Americans with Disabilities Act Accessibility Survey

Self-Evaluation and Transition Plan

Sarpy County Historical Museum

2402 Clay Street
Bellevue, Nebraska 68005

West Accessible Space

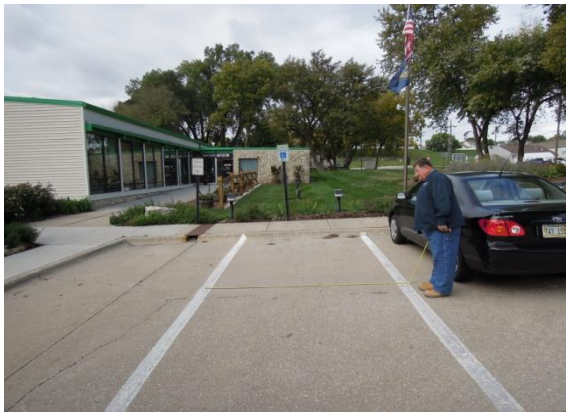
Code	502.3.3 Marking
Code Description	Access aisles shall be marked so as to discourage parking in them.
Finding	East accessible space is compliant. West accessible space is not compliant.
Compliant?	**NO**
Recommended Repair (if needed)	Hatch stall to south marked "Seniors". This will provide access aisle.

East Sign Measurement

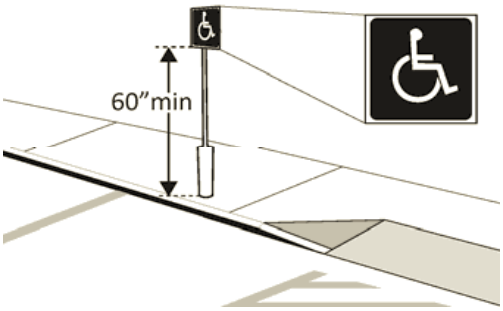
Code	502.6 Identification
Code Description	Parking space identification signs shall include the International Symbol of Accessibility complying with 703.7.2.1. Signs identifying van parking spaces shall contain the designation "van accessible." Signs shall be 60 inches minimum above the finish floor or ground surface measured to the bottom of the sign.
Finding	Accessible spaces are identified with a sign that includes the International Symbol of Accessibility. The bottom of the west sign is 64" above the ground. The bottom of the east sign is only 58" above the ground.
Compliant?	**NO**
Recommended Repair (if needed)	Raise sign to meet requirement.

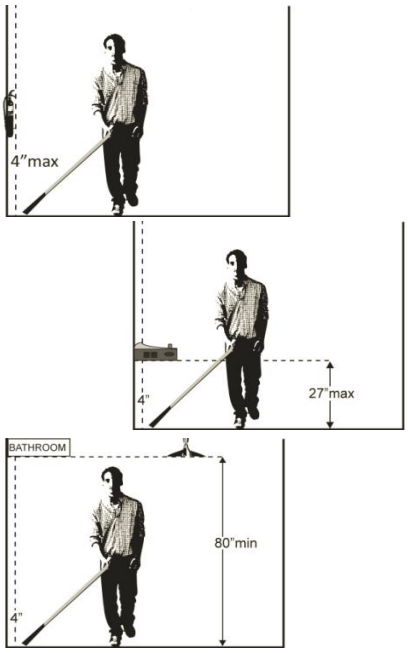
Code	307.2 Protrusion Limits
Code Description	Objects with leading edges more than 27 inches and not more than 80 inches above the finish floor or ground shall protrude 4 inches maximum horizontally into the circulation path.
Finding	Bicycle pedal protrudes 5-1/2 inches with a bottom leading edge of 48 inches.
Compliant?	**NO**
Recommended Repair (if needed)	Add tactile warning such as a permanent planter or partial wall

Knee Space Height

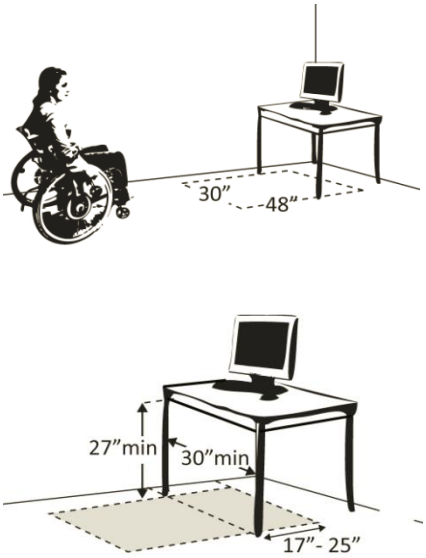
Code	305.3 Size; 306.2.2 Maximum Depth; 306.2.3 Minimum Required Depth; 306.3.1 General; 306.3.5 Width
Code Description	305 - The clear floor or ground space shall be 30 inches minimum by 48 inches minimum. 306.2.2 - Toe clearance shall extend 25 inches maximum under an element. 306.2.3 - Where toe clearance is required at an element as part of a clear floor space, the toe clearance shall extend 17 inches minimum under the element. 306.3.1 - Space under an element between 9 inches and 27 inches above the finish floor or ground shall be considered knee clearance and shall comply with 306.3. 306.3.5 - Knee clearance shall be 30 inches wide minimum.
Finding	There is clear floor space measuring 55" x 72" for a forward approach. Clear floor space extends 19-1/2" under the surface. The knee space measures 24-1/2" high and 26-1/2" wide.
Compliant?	**NO**
Recommended Repair (if needed)	Adjust work surface knee space.

Restroom Sign

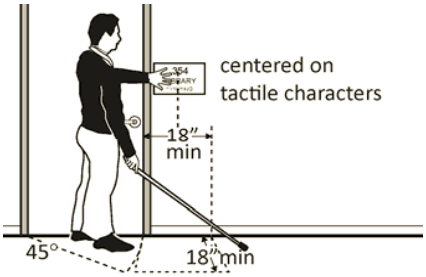
Finding	Signs have contrasting raised characters and Braille. The sign is mounted on the face of the door.
Compliant?	**NO**
Recommended Repair (if needed)	Move sign to wall on latch side of door.

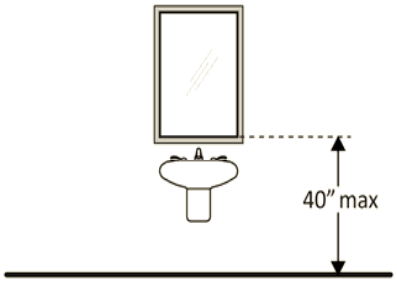
Code	603.3 Mirrors
Code Description	Mirrors located above lavatories or countertops shall be installed with the bottom edge of the reflecting surface 40 inches maximum above the finish floor or ground. Mirrors not located above lavatories or countertops shall be installed with the bottom edge of the reflecting surface 35 inches maximum above the finish floor or ground.
Finding	Men's Room: 42" Women's Room: 42"
Compliant?	**NO**
Recommended Repair (if needed)	Lower mirror.

Men's Restroom Flush Control

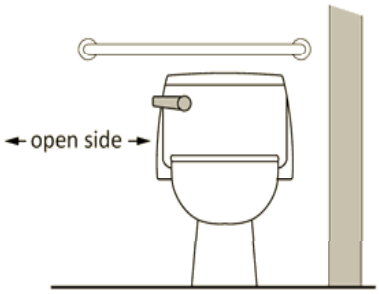
Code	309.4 Operation
Code Description	Operable parts shall be operated with one hand and shall not require tight grasping, pinching, or twisting of the wrist. The force required to activate operable parts shall be 5 pounds maximum.
Finding	The flush control can be operated with one hand without tight grasping, pinching, or twisting of the wrist; however, the force required is 5-1/2 pounds.
Compliant?	**NO**
Recommended Repair (if needed)	Adjust or change control.
